## LEGAL NOTICE EXETER PLANNING BOARD AGENDA

The application of C/A Design, Inc. (Wakefield Thermal) for a site plan review for the proposed construction of a 40,000 SF addition to an existing industrial building, expanded parking, loading areas and associated site improvements on the property located at 131 Portsmouth Avenue. The subject property is located in the CT-Corporate Technology Park and C-2 Highway Commercial zoning districts. Tax Map Parcel #52-112. PB Case #23-4.

**Date:** April 6, 2023  
**To:** Planning Board  
**From:** Dave Sharples, Town Planner  
**Re:** Richard & Debbi Schaefer PB Case #23-3

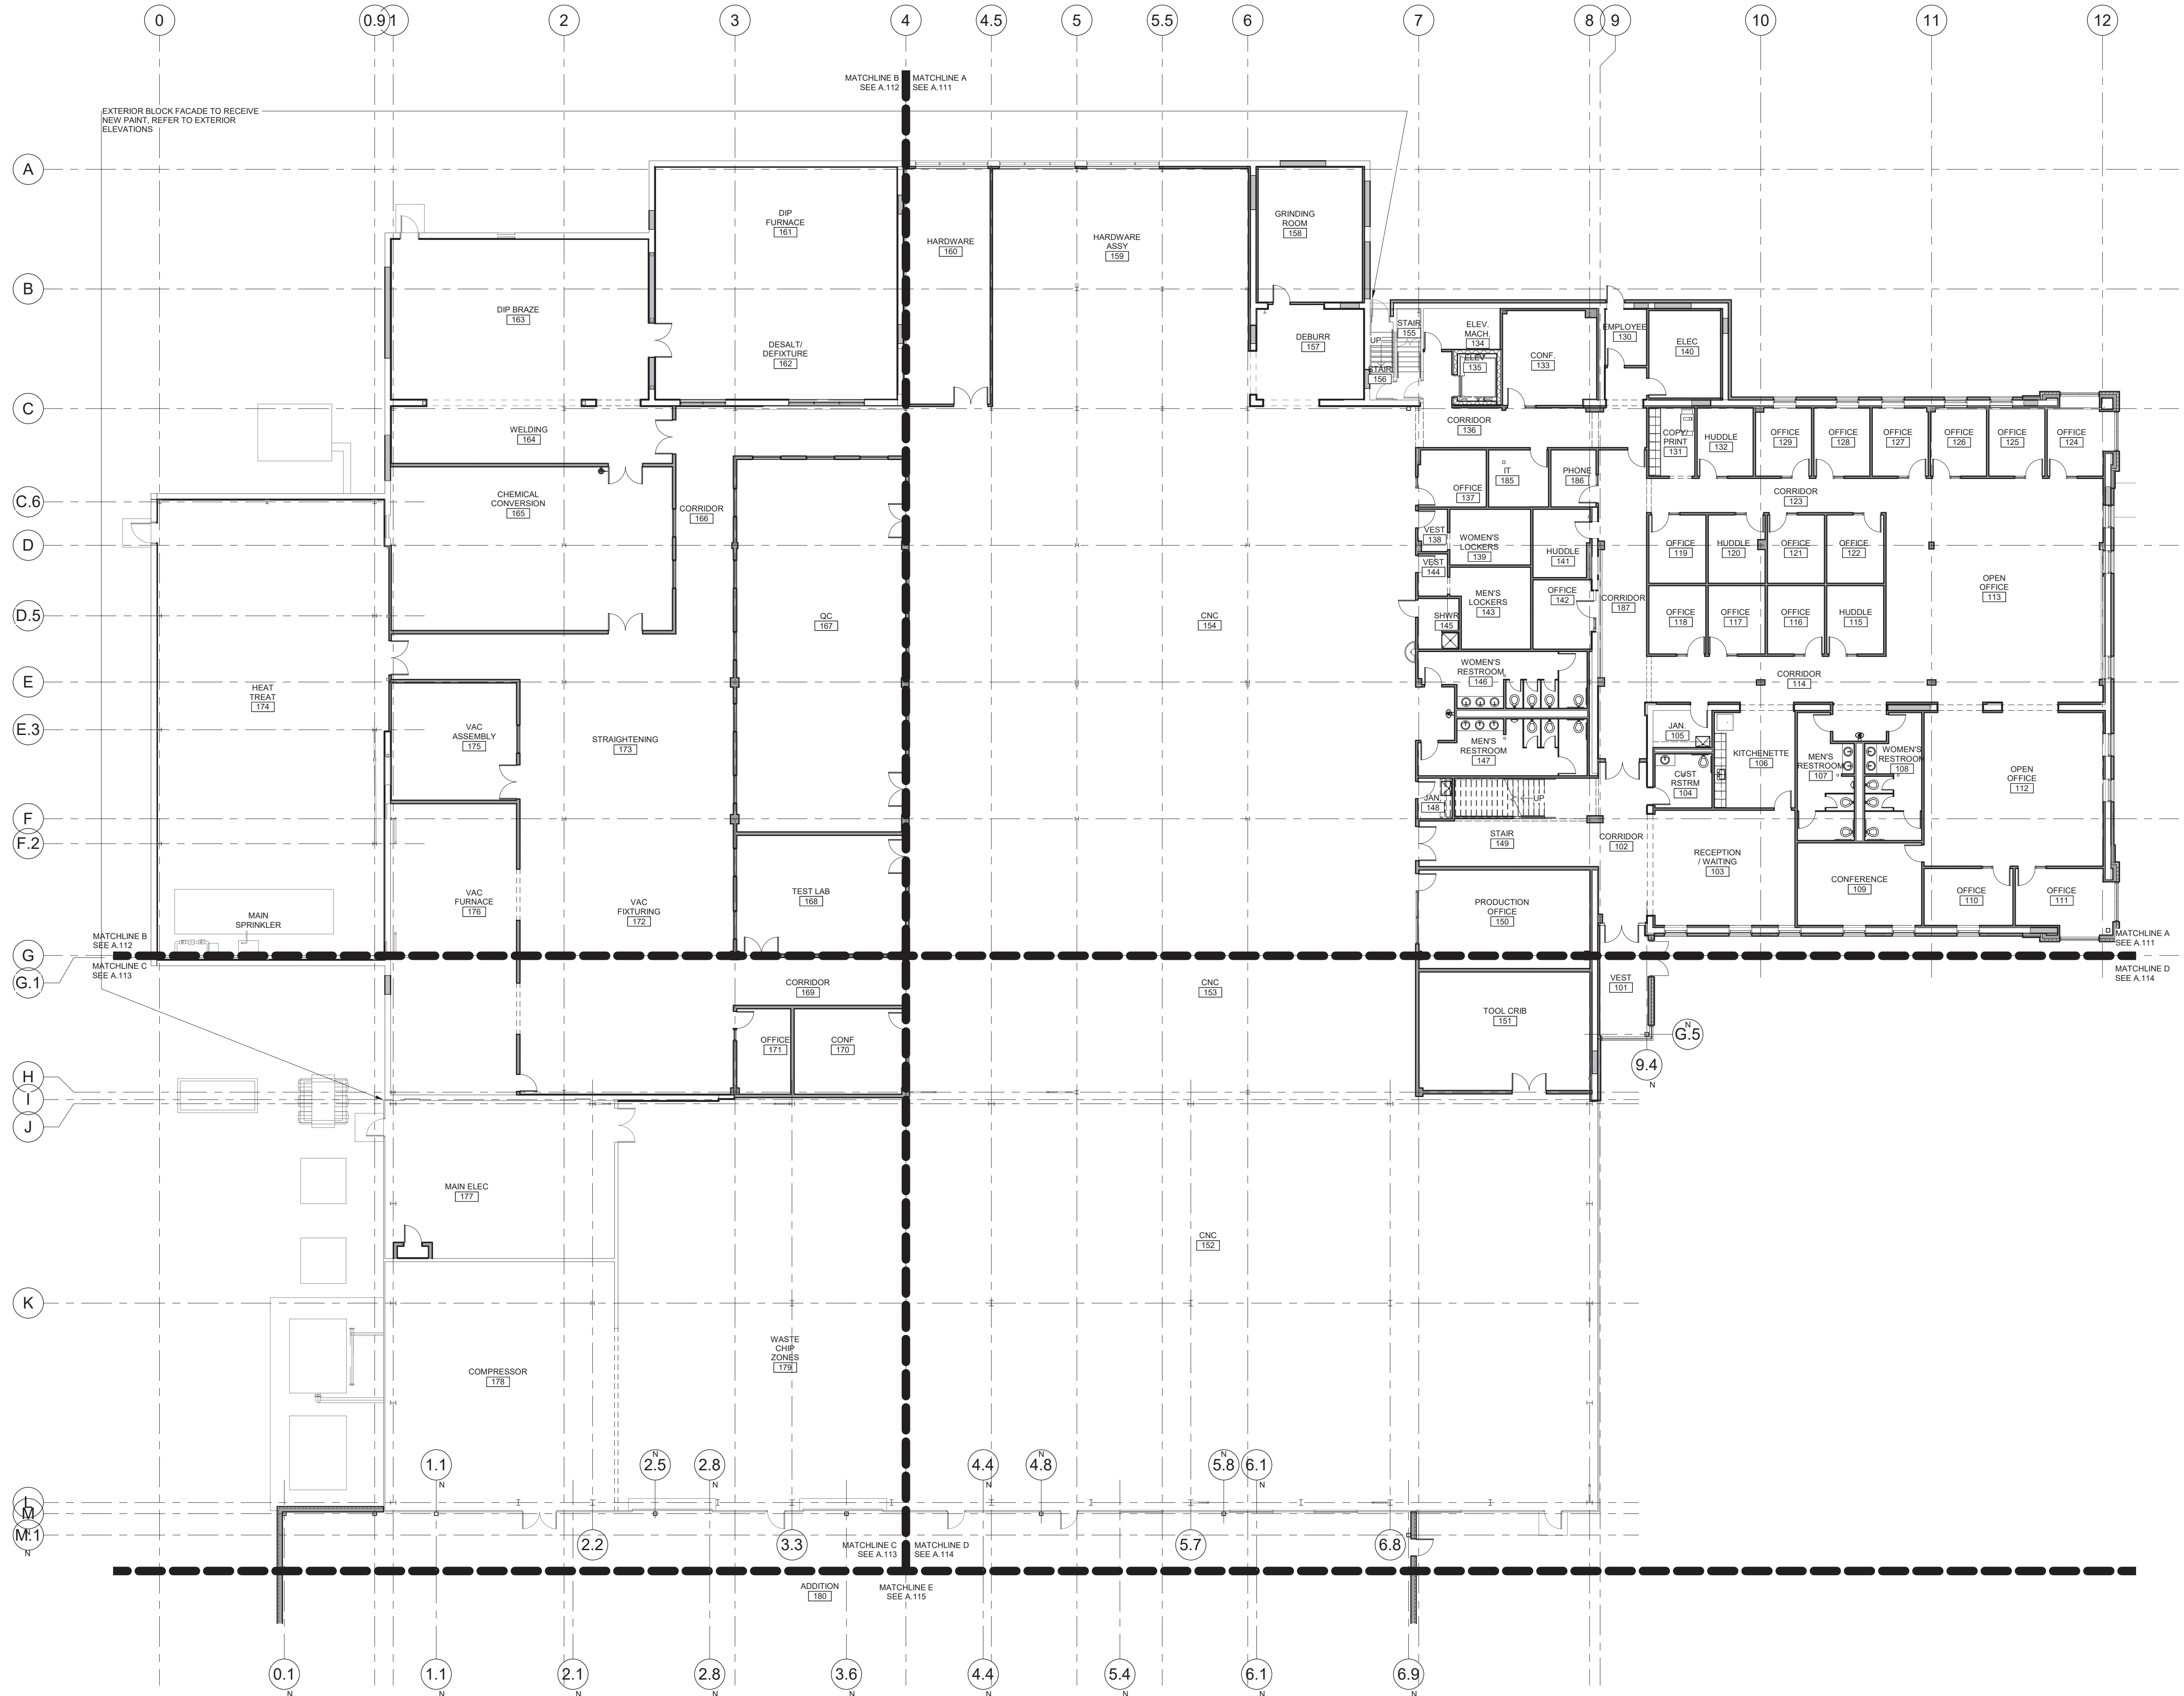
26. The Isolator Row detail on sheet C-17:
  - Sump depth is deferred to the site design engineer. Revise this note to indicate the sump depth proposed.
  - A note on the detail recommends inserts in upstream structures with open grates. It is not clear if these inserts will be installed.
27. Add the following details:
  - Lined concrete washout area.
  - Grease interceptor, if applicable.
  - Equipment pads for exterior HVAC units, transformer, etc. as applicable.

26. The Isolator Row detail on sheet C-17:

26. The Isolator Row detail on sheet C-17:
  - UE acknowledges that the insert and note has been removed from the detail. We understand that the intent is to remove the inserts once construction is complete, but we concur with ADS’ recommendation that the inserts should be used during construction to protect the system from construction debris.
